Submission for Job: #7485 WestConnex M4-M5 Link
https://majorprojects.acelo.com/?action=view_job&id=7485

15 October, 2017
Attention: Director – Transport Assessments

Application Number: SSI 7485 Application
Name: WestConnex M4-M5 Link

Figure 6-4 Project footprint - Map 2

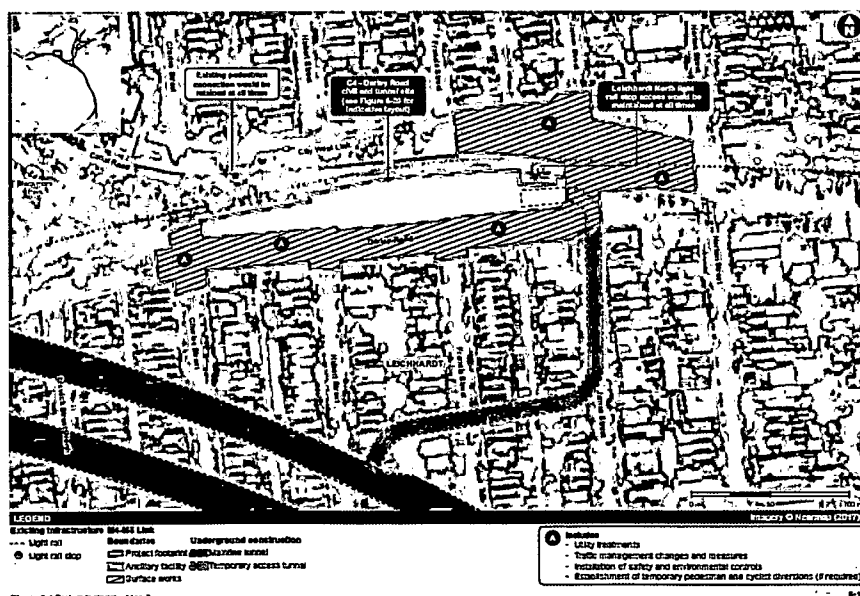
- I **object** to the EIS because it does not guarantee that the existing access to the Leichhardt North light rail stop would be maintained at all times. Fig 6-4 indicates that only the eastern access will be maintained. This greatly disadvantages the elderly and disabled who have to walk up a steep hill to the eastern access. If the proponent cannot guarantee access to the Leichhardt North light rail stop from the existing entry points or from points that are accessible to all then the Darley Road, Leichhardt construction site should be abandoned. The proponent should be directed to find a site where its operations will not impact on users of the Light Rail.

Figure 6-4 Project footprint - Map 2

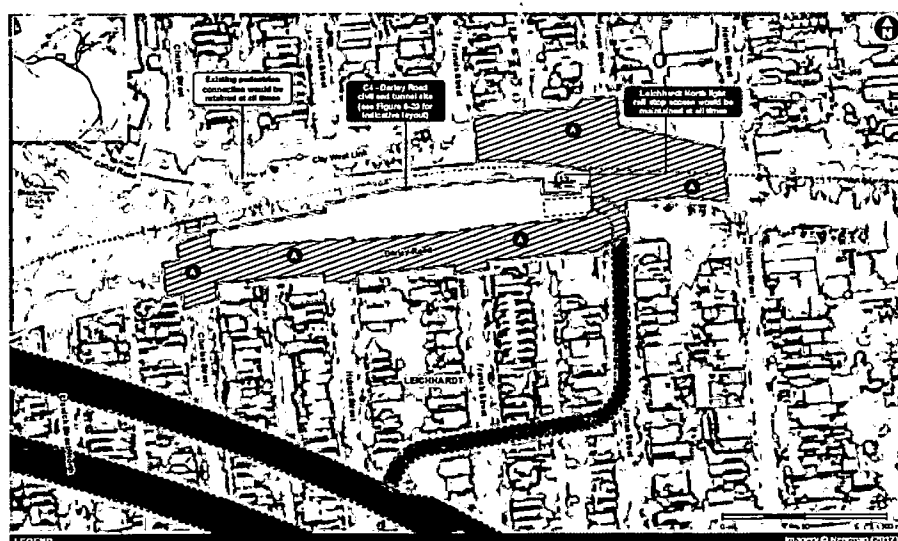
- I object to the EIS because it does not guarantee that the existing access to the Leichhardt North light rail stop would be maintained at all times. Fig 6-4 indicates that only the eastern access will be maintained. This greatly disadvantages the elderly and disabled who have to walk up a steep hill to the eastern access. If the proponent cannot guarantee access to the Leichhardt North light rail stop from the existing entry points or from points that are accessible to all then the Darley Road, Leichhardt construction site should be abandoned. The proponent should be directed to find a site where its operations will not impact on users of the Light Rail.

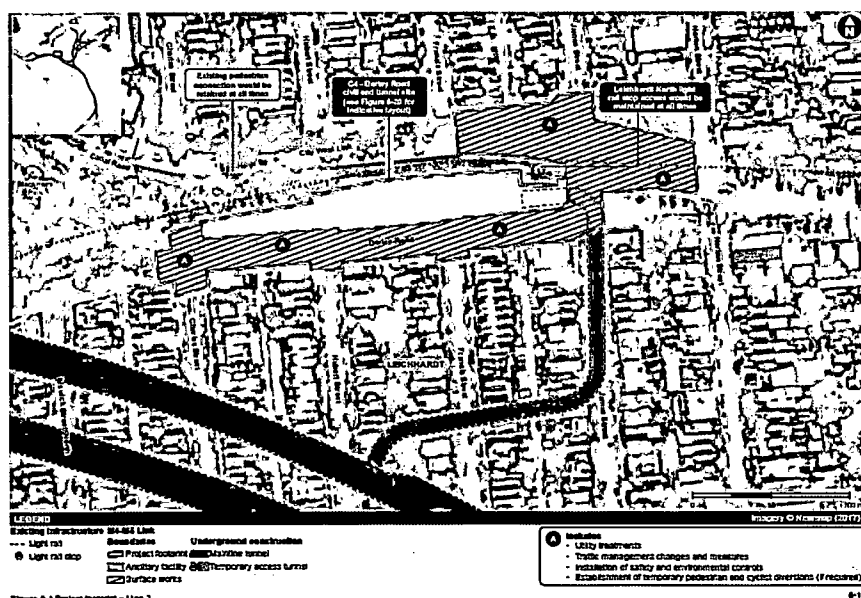
- I object** to the EIS because it fails to describe the temporary changes to Darley Road, Leichhardt to enable access to and from the ancillary facility that would likely be required in relation to the Darley Rd site and instead allows for the final plan to be decided by the contractor.

The EIS states in 6.5.8 Darley Road civil and tunnel site (C4) that:

'Temporary changes to Darley Road to enable access to and from the ancillary facility would likely be required. These may include changes to line marking to provide a temporary turning lane for construction traffic and temporary diversions to the pedestrian path on the northern side of Darley Road. These would be confirmed during detailed design following the appointment of a design and construction contractor and in consideration of the safety and function of the road network, maintaining access to the Leichhardt North light rail stop and providing for continued pedestrian and cyclist movement.'

It is not clear how continued access, pedestrian and cyclist movement will be preserved and I am concerned that the impacts have not been correctly identified and assessed by the proponent.
